re: **Geotechnical Design Summary Details**
Proposed Residential Development
5331 Fernbank Road – Ottawa, Ontario

file: PG5683-MEMO.02 Revision 5

Further to your request, Paterson Group (Paterson) prepared the current memorandum to provide a grading, servicing and landscape review for the proposed residential development. The following memorandum should be read in conjunction with the Geotechnical Investigation Report (Paterson Report PG5683-1 Revision 1, dated November 13, 2025).

DRAWING NAME: GENERAL PLAN OF SERVICES

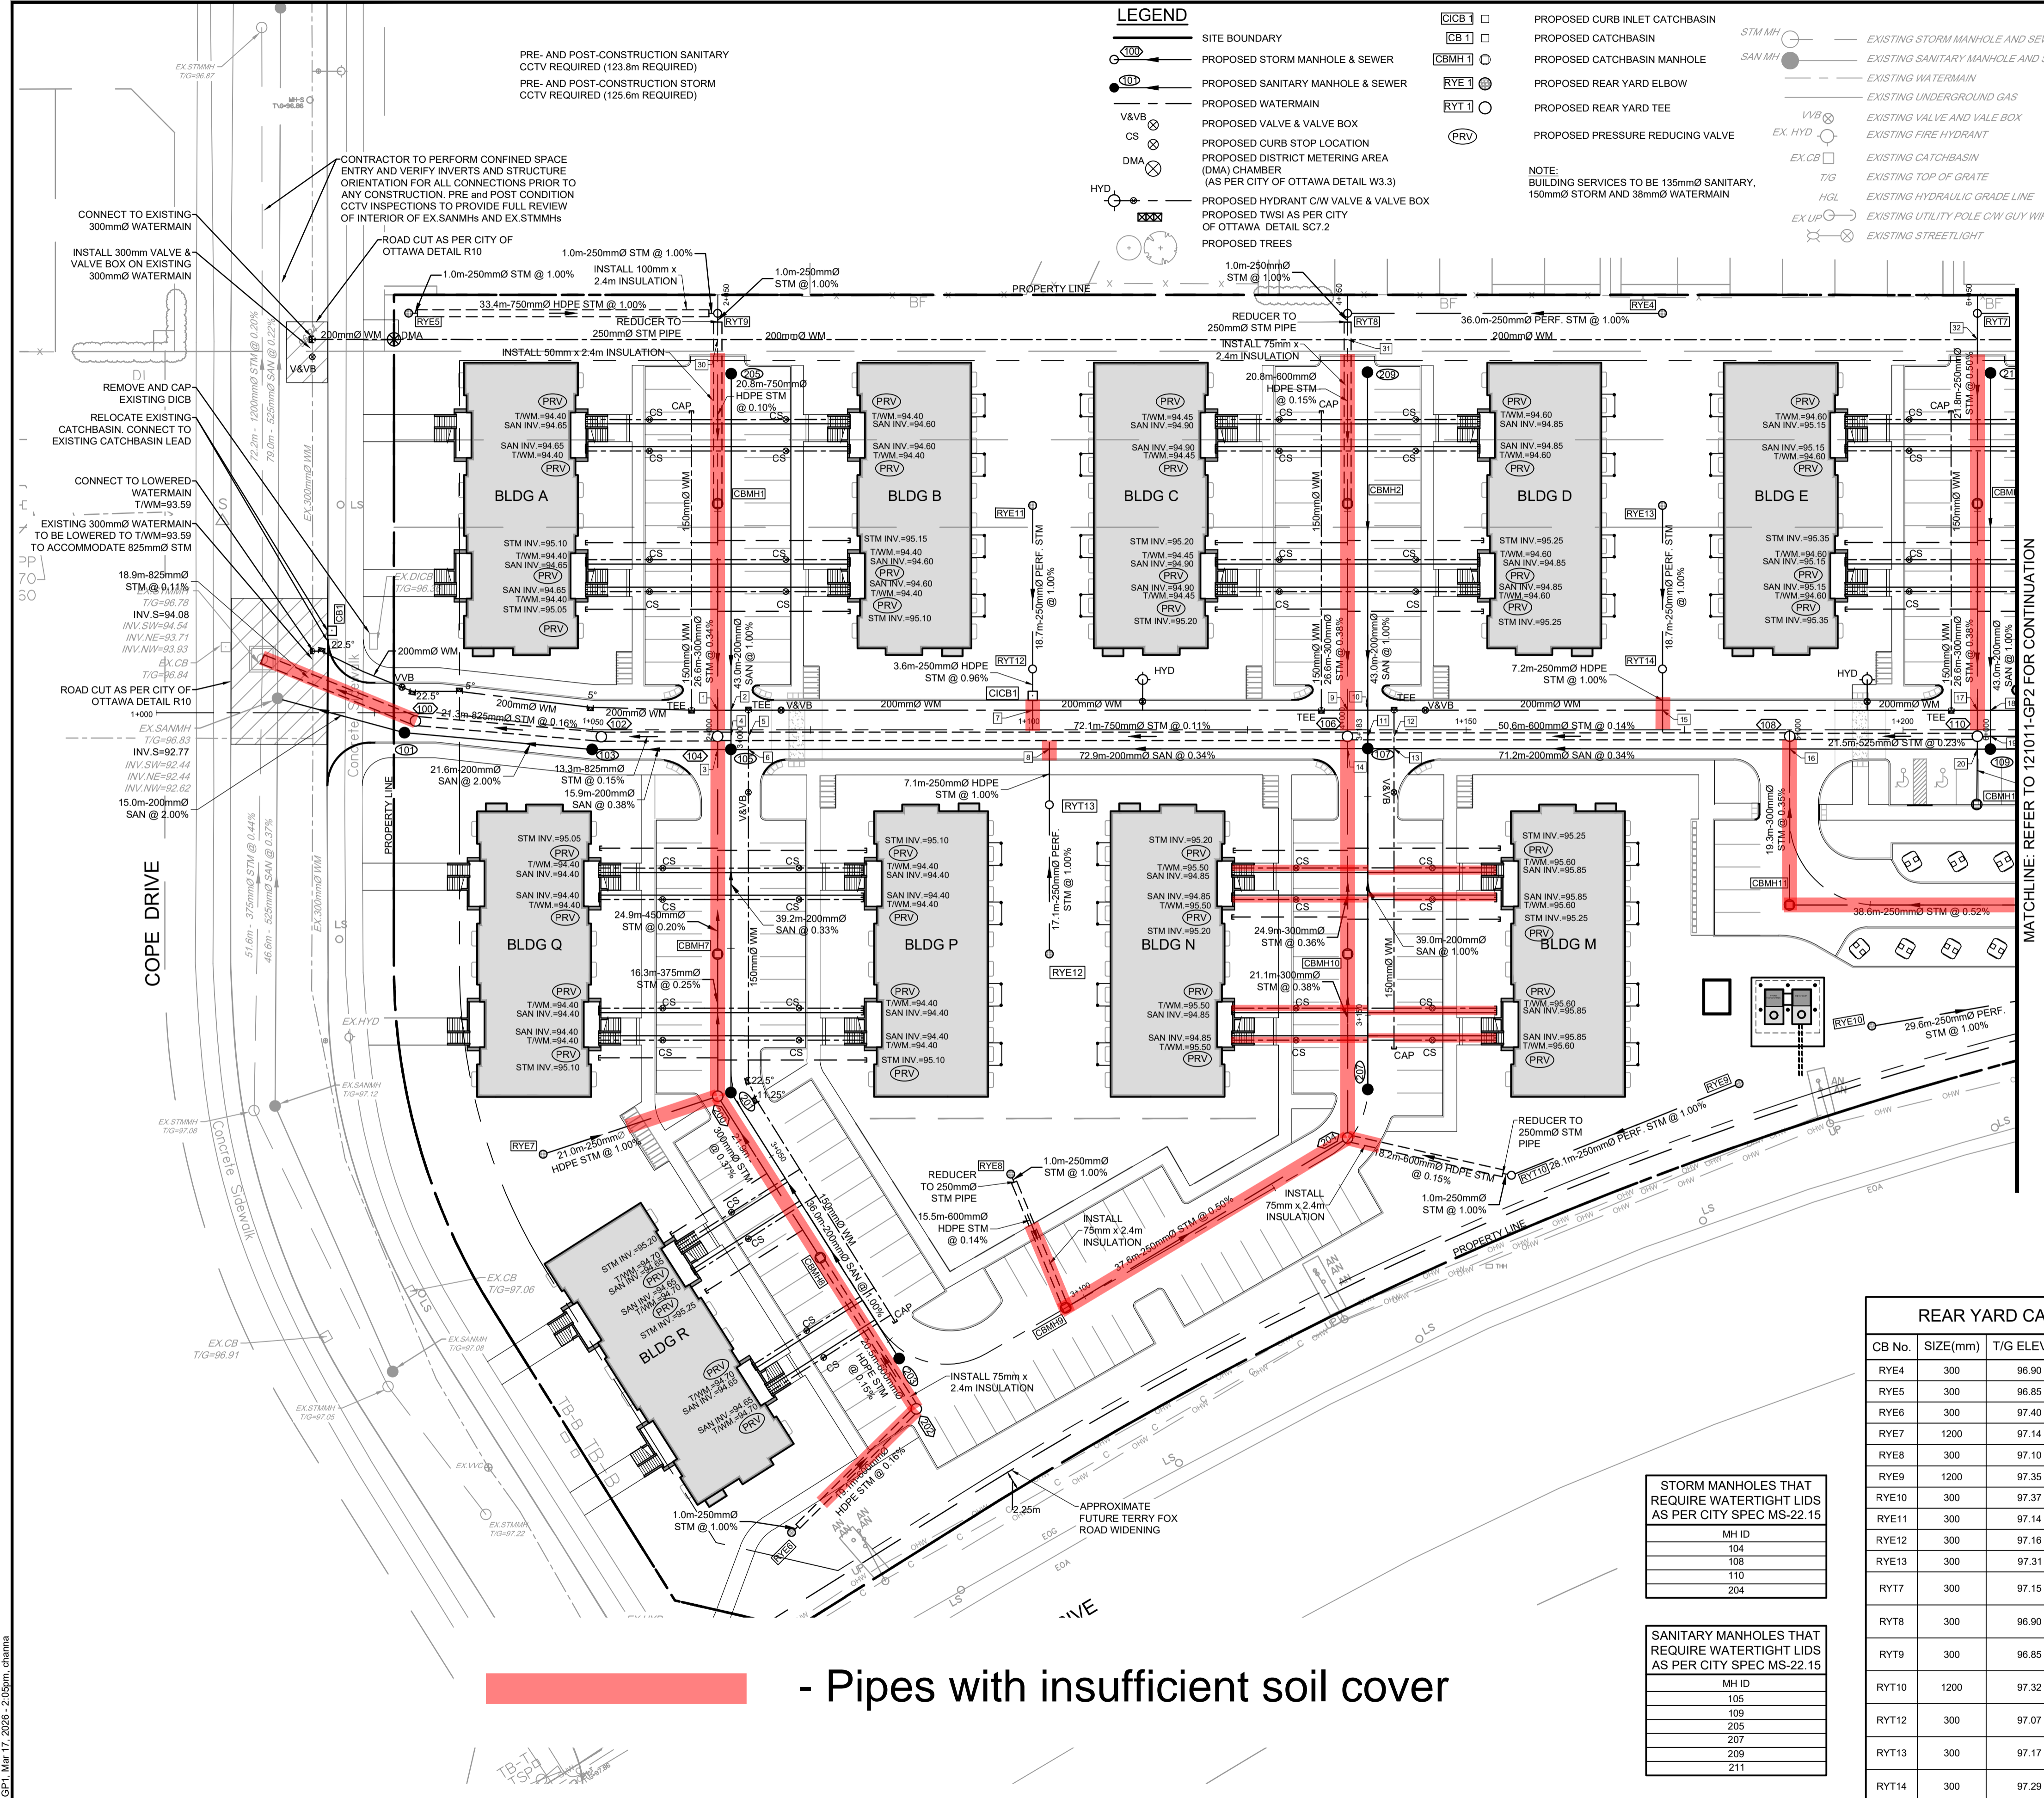
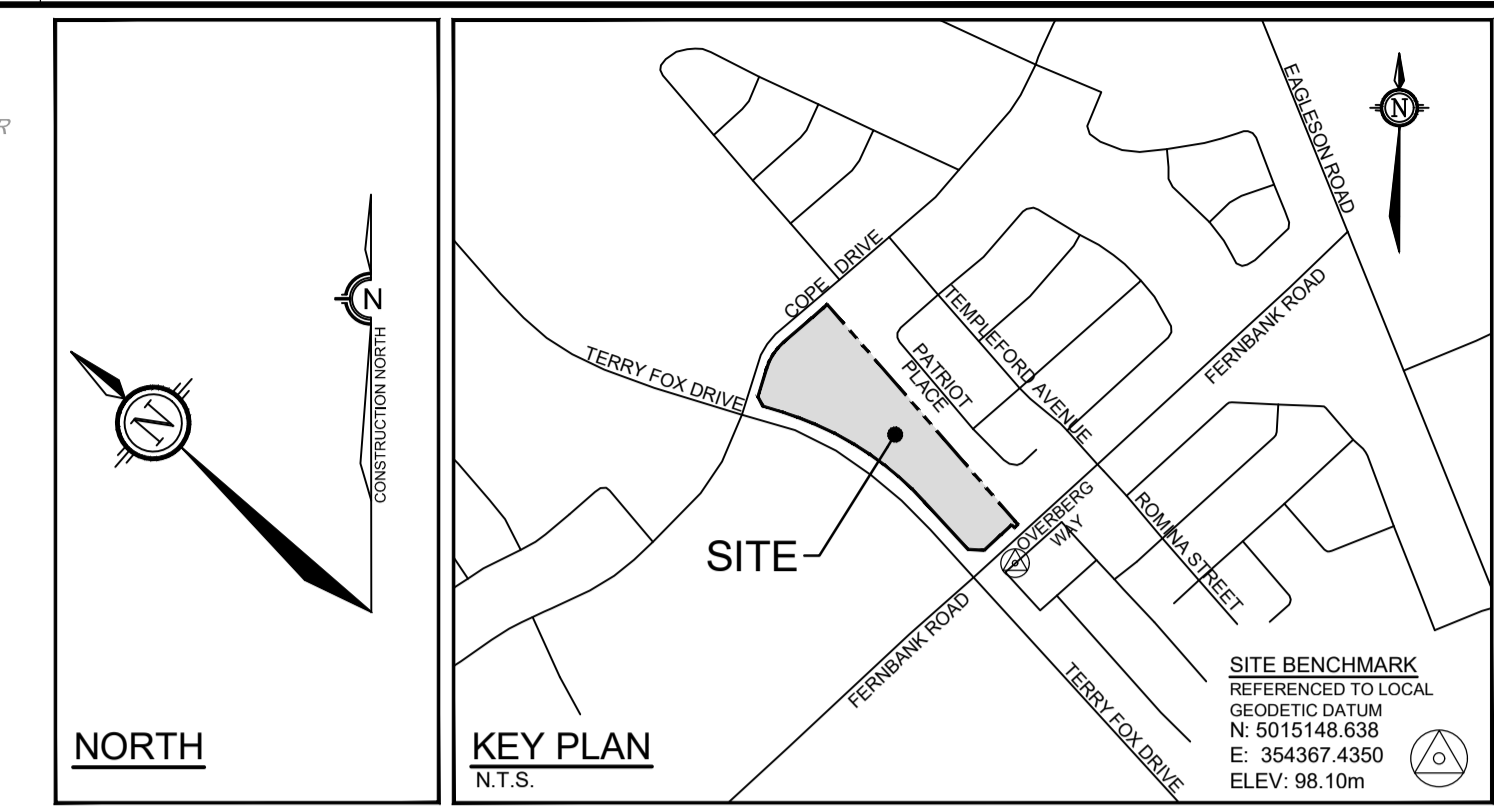
From our review of the above-noted site servicing plan, a number of servicing pipe sections are not provided with sufficient soil cover of 2.1 m for adequate frost protection (measured from the proposed ground surface to the pipe obvert). Reference should be made to the marked-up servicing plans which show the areas with insufficient soil cover, attached to the current report.

- Pipes with insufficient soil cover

For services with less than 2.1 m soil cover, a combination of soil cover and rigid insulation should be used, as detailed in Table 2 on the following page.

Thermal Condition	Soil Cover Provided (mm)	Insulation Dimensions	
		Thickness (mm)	Extension (mm)
Unheated	1800-2000	25	Extend 600 mm horizontally beyond edge of the pipe
	1500-1800	50	Extend 900 mm horizontally beyond edge of the pipe
	1200-1500	75	Extend 1200 mm horizontally beyond edge of the pipe

Alternatively, instead of extending the rigid insulation 600 to 1200 mm beyond the edge of the pipe, the rigid insulation can be “boxed” around the pipe by transitioning from horizontal to vertical placement of the rigid insulation and extending to the invert pipe elevation, effectively forming a box of rigid insulation around the pipe. In this case, the rigid insulation should still be extended far enough to provide adequate spring-line and cover backfill material around the pipe.
